IMPORTANT SAFETY RECALL

NHTSA Recall Number: 26V386
Altec Identifier: CSN-3331

JEMS Missing Transmission Interlock

Figure 1 — Inpower Module Installed (Example Only)

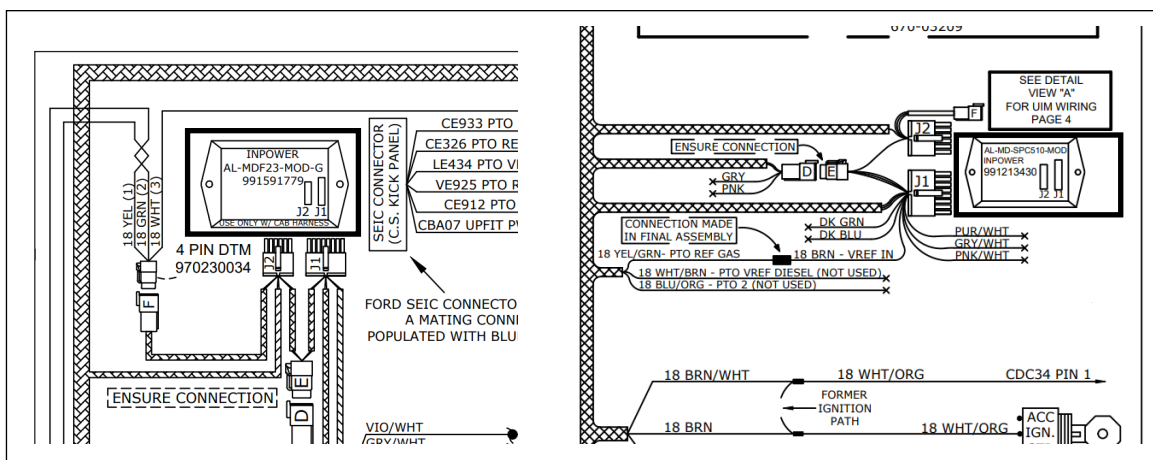
2. Review the schematic and confirm if an Inpower module is installed (refer to Figure 1). Note that Figure 1 is an example only as installation and schematics will vary between units.
 - If an Inpower module is installed, kit 992163623 is required for repair.
 - The kit for Ford chassis with no Inpower module installed is not immediately available due to supplier backorder. Altec will send a second notice with the kit part number when the kit is available for order.
